PERRY PLACE SUBDIVISION, REVISED

Engineering Comments: FINAL PLAT COMMENTS (should be addressed prior to submitting the FINAL PLAT for review and/or signature by the City Engineer):

APPLICATION NUMBER 8 DATE September 5, 2019

DETAIL SITE PLAN

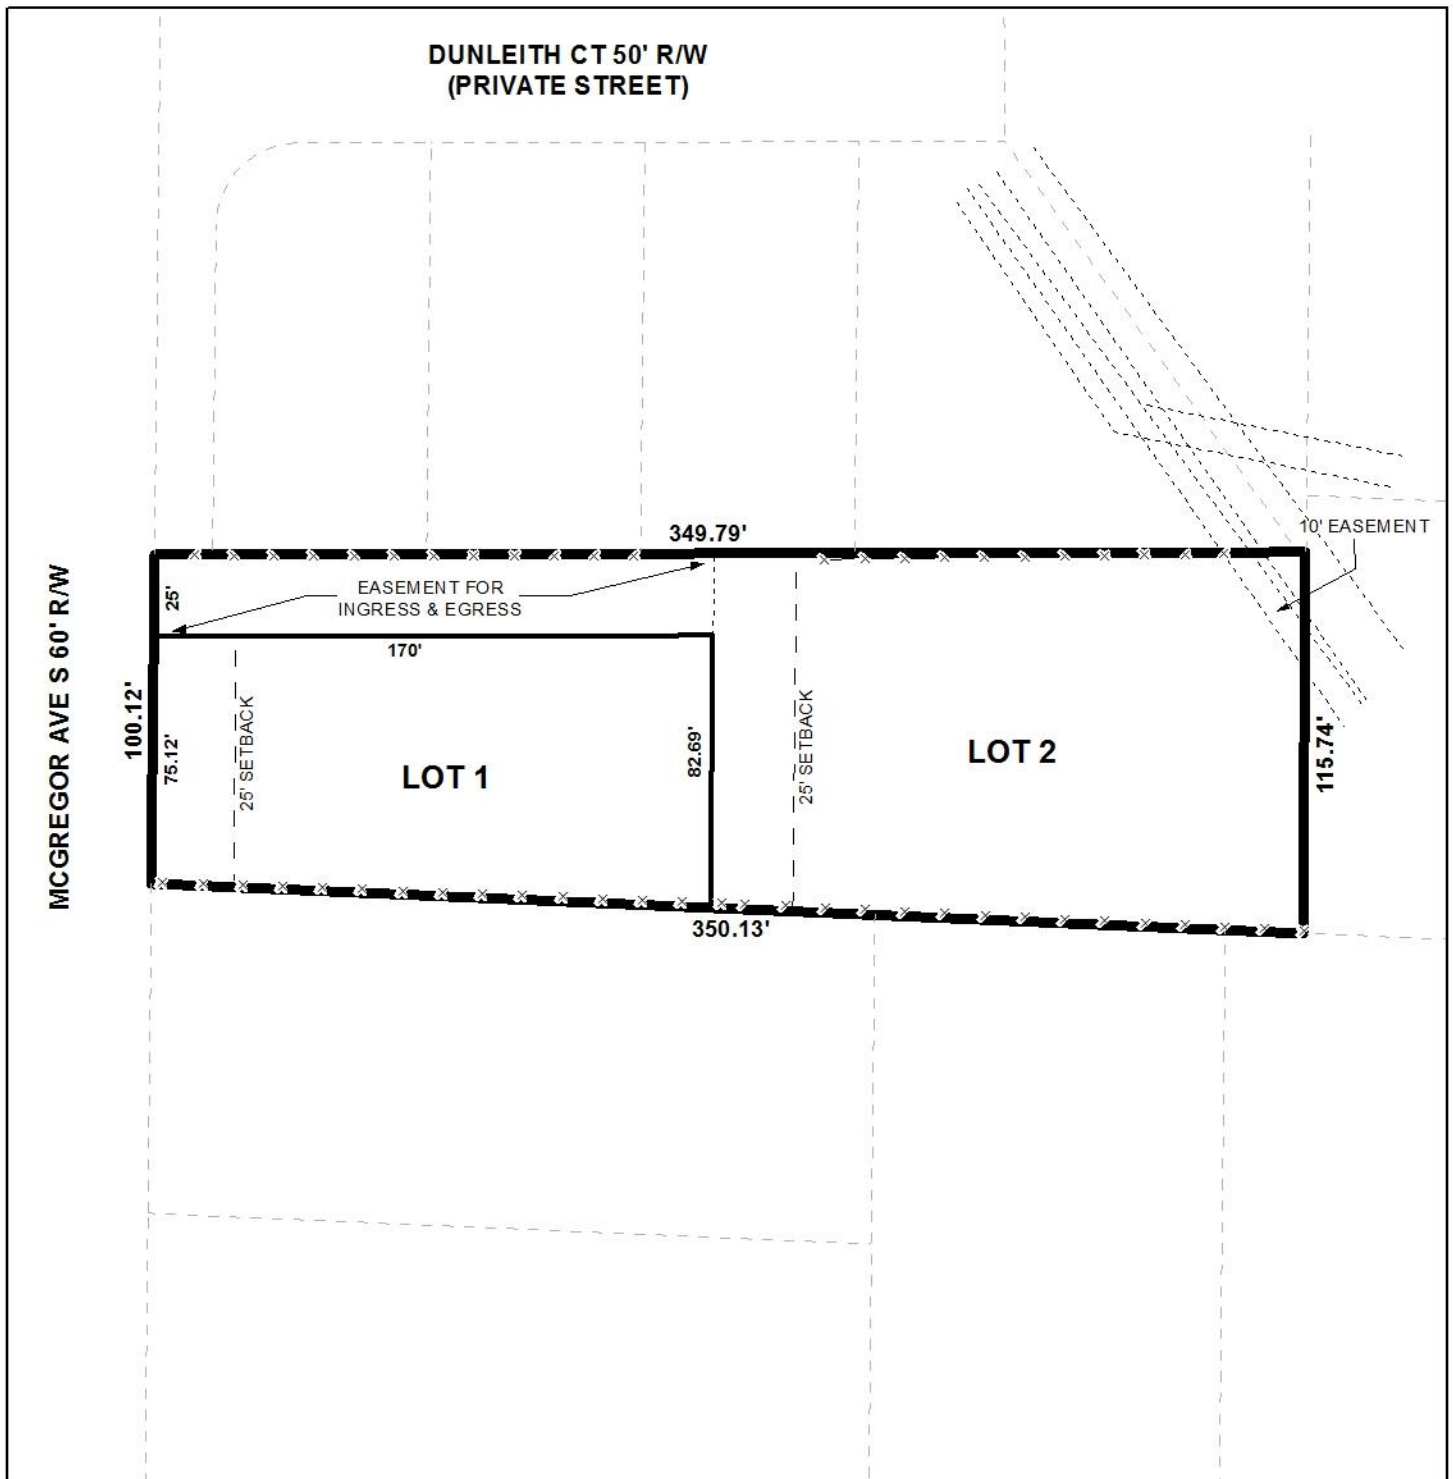
way is needed. As such, sufficient right-of-way is illustrated on the preliminary plat and no additional dedication should be required. The Preliminary Plat indicates a 25' minimum building setback which should be retained on the Final Plat, if approved.

Proposed Lot 2 is irregularly shaped and may be regarded as a "panhandle" lot, a design discouraged by Section V.D.1. of the Subdivision Regulations; the exception being the approval of lots located where varied and irregularly-shaped lot designs are common, and the informality of design is consistent with other lots in the vicinity. The Planning Commission has approved a similar design for several lots within the vicinity of the subject site; therefore, a waiver of Section V.D.1. may be appropriate.

The lots meet the minimum size requirements for lots served by public water and sanitary sewer systems. The sizes of each lot in both square feet and acres should be retained on the Final Plat, if approved; or, provision of a table on the Final Plat providing the same information may suffice.

In addition to the 25' ingress/egress easement, a 10' sewer easement is illustrated on the Northeast corner of Lot 2. As such, a note should be placed on the Final Plat stating no structures shall be constructed in any easement.

- 1) retention of a 25' minimum building setback line along both lots where they are at least 60' wide;
- 2) retention of the lot size in both square feet and acres, or the furnishing of a table on the Final Plat providing the same information;

- 3) placement of a note on the Final Plat stating that no structure may be constructed or placed within any easement (if applicable);
- 4) compliance with Engineering comments: *(FINAL PLAT COMMENTS (should be addressed prior to submitting the FINAL PLAT for review and/or signature by the City Engineer): A. Provide all of the required information on the SUBDIVISION PLAT (i.e. signature blocks, signatures, certification statements, written legal description, required notes, legend, scale, bearings and distances) that is required by the current Alabama State Board of Licensure for Professional Engineers and Land Surveyors. B. Provide the Surveyor's, Owner's (notarized), Planning Commission, and Traffic Engineering signatures. C. Add a note to the SUBDIVISION PLAT stating that as LOTS 1 and 2 will not receive any historical credit of existing (1984) impervious area towards stormwater detention requirement per Mobile City Code, Chapter 17, Storm Water Management and Flood Control). Each LOT must submit a TIER 2 Land Disturbance Permit and include stormwater detention. D. Add a note to the SUBDIVISION PLAT stating that a Land Disturbance permit will be required for any land disturbing activity in accordance with Mobile City Code, Chapter 17, Storm Water Management and Flood Control; the City of Mobile, Alabama Flood Plain Management Plan (1984); and, the Rules For Erosion*
